# Norfolk Boreas Offshore Wind Farm Applicant's Comments on Natural England and the MMO's Deadline 14 Submissions

Applicant: Norfolk Boreas Limited  
Document Reference: ExA.ASR.NE.MMO.D15.V1  
Deadline 15

Date: August 2020  
Revision: Version 1  
Author: Royal HaskoningDHV

Title:  
 Geographical illustration of maximum area or cable protection

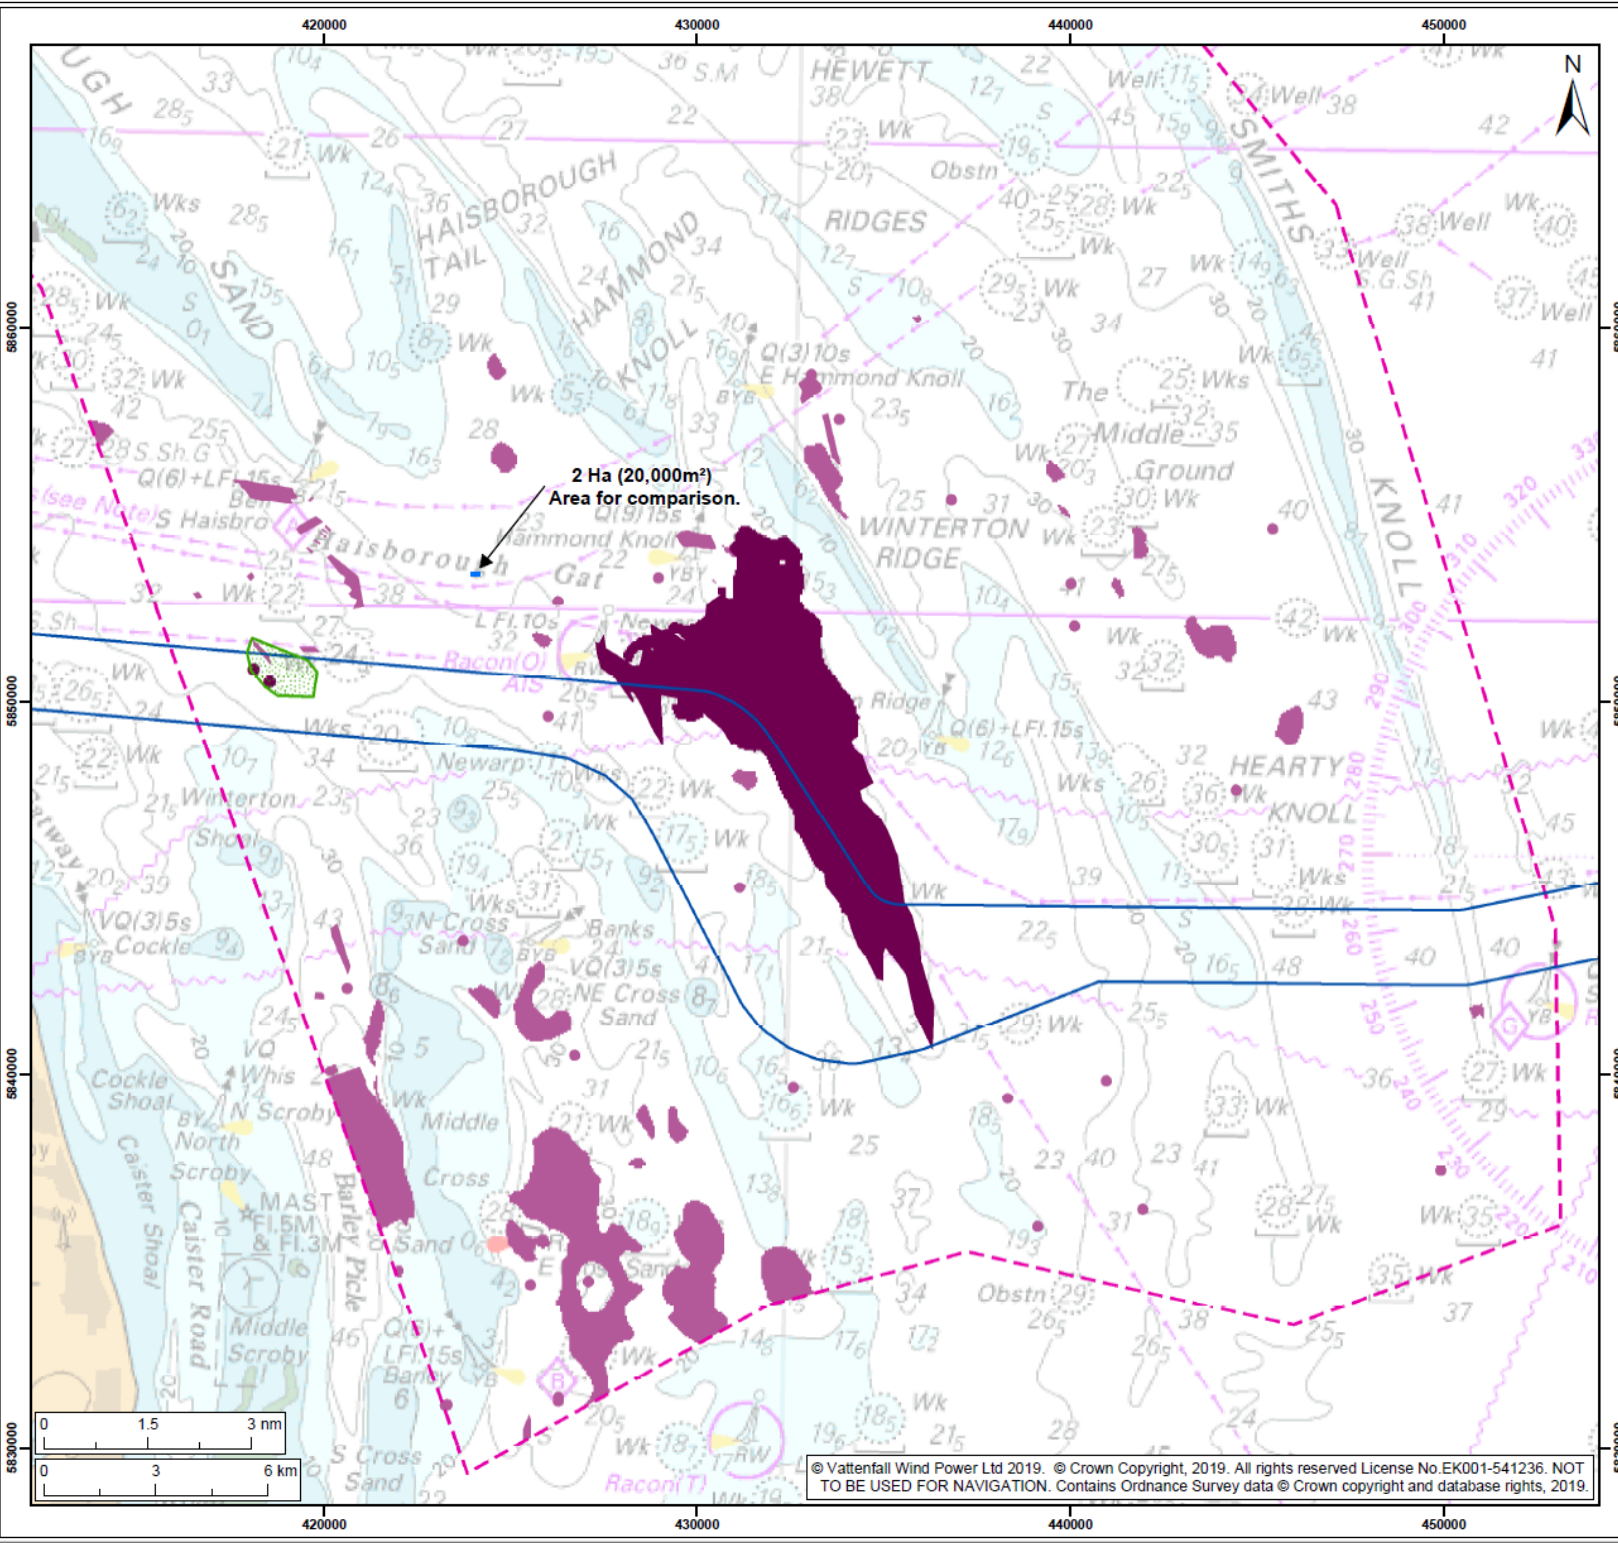
Summary of Submission	Applicant's Comments
<p>which are considered to be small scale. However there are three points' NE wishes to highlight the decisions don't take account of:</p> <p>a) changes to form and function listed under the Conservation Objectives: We advise that all regulators when undertaking an HRA should be considering the conservation objectives for the site and should have regard for our conservation advice, which consider more than just extent. This is key because the MMO follow the above approach in their assessments so post consent/pre construction the AAs are unlikely to align with the original SoS HRA.</p> <p>b) the favourable condition of the site: The decision making process needs to understand decisions that have already been made in the site and the implications for favourable condition status which whilst noted in the HRA haven't been fully considered. We advise that the favourable condition status of HHW SAC as published in 2019 should be taken into consideration in any decision making</p> <p>c) the actual scale of the impacts: Whilst we recognise that the impacts are small scale in comparison to the whole site it should be noted that 5% of cable protection within the HHW SAC is equivalent to WCS two residential roads running in parallel for 2km through the site or 4 roads if you take into account Boreas.</p>	<p>decommission cable protection means that the impact is considered long term temporary whereas Hornsea Project Three do not have such a commitment and therefore the impact is permanent.</p> <p>a) The Applicant's Information to Support HRA Report [APP-201] and subsequent supplementary assessments [REP10-043] do consider the extent of the impact using Natural England's advice note regarding consideration of small scale habitat loss within SACs [REP1-057] within the context of the conservation objectives, which takes into account changes in form and function. Natural England has recognised in REP9-045 "<i>the advantages of the low profile</i> [of types of cable protection which the Applicant will be required to use in the HHW SAC to ensure that decommissioning is possible, as secured by condition 3(1)(g)] <i>which is likely to allow natural processes to function.</i>" However the statements made in 5a) appear to contradict this previous advice.</p> <p>b) The Applicant's Information to Support HRA Report [APP-201] and subsequent supplementary assessments [REP10-043] do also consider the status of the site. The site is currently assessed by Natural England as being in unfavourable condition. Although this information was published after the Applicant made its Application in June 2019 (i.e. in November 2019), the Applicant was made aware, through the Norfolk Vanguard examination, that the imminent assessment was likely to conclude that both designated features and therefore the site were in unfavourable condition. Therefore, the Applicant was able to take account of this within its Information to Support HRA Report [APP-201] assessment.</p> <p>c) The Applicant notes Natural England's illustration of the scale of the cable protection and would like to make it clear that this is the maximum possible length that would be occupied by cable protection and that the Applicant would, through development of the HHW SAC control document, seek to minimise the area of cable protection as far as possible which may be to a point where no cable protection is required at all (apart from at the two remaining cable crossings) and furthermore it is very unlikely that this would be for a continuous '2km' stretch, but instead would be broken into sections. Furthermore none of the cable protection would be placed within the areas identified as priority areas to be managed for Annex I <i>S.spinulosa</i> reef (see Figure 4.1 of the CSIMP [REP14-031] and Figure 5.1 of the SIP [REP14-033]). The Applicant also provided an illustration of the scale of the maximum size of the area of</p>

Summary of Submission	Applicant's Comments
	<p>impact at Issue Specific Hearing 4 (Offshore effects including the draft Development Consent Order). See Appendix 3 of REP4-014 which has also been reproduced below for ease of reference. More generally, the Applicant questions the usefulness of drawing comparisons to two or four residential roads in this context.</p>
<p><b>6. Disposal Location</b></p> <p>4.20.18 of the NVG ExA report agrees with NE that there needs to be a disposal condition that ensures that dredged material will be disposed of in similar habitat locations. And whilst the SIP was identified in the NVG HRA as having a requirement to agree disposal location/s with MMO in consultation with NE prior to construction; we would welcome some outline agreement on the criteria that should be met for any disposal site beyond those currently included in the CSIP including, but not exclusively, similar grain size.</p>	<p>The Applicant is unsure whether this applies to Norfolk Boreas as it is stated by Natural England within the SoCG [REP10-038]</p> <p><i>"In [REP4-043] Natural England confirmed that the proposed disposal location is acceptable to and welcomed retention within the SAC sandbank system."</i></p> <p>The Applicant has engaged with Natural England (in addition to the MMO) throughout the examination to seek advice on how ensuring similar grain size could be achieved. To date neither the MMO nor Natural England (who made the request originally) have been able to provide any practical, workable alternative to the Applicant's proposed approach.</p> <p>Although it is unclear, the Applicant understands that Natural England is referring to the SIP/CSIMP when it states the CSIP. Hornsea Project 3 use a Cable Specification and Installation Plan (CSIP) as a means of mitigating impacts to the North Norfolk Sandbanks and Saturn Reefs SAC. Norfolk Boreas has not proposed the use of a CSIP at any point.</p>
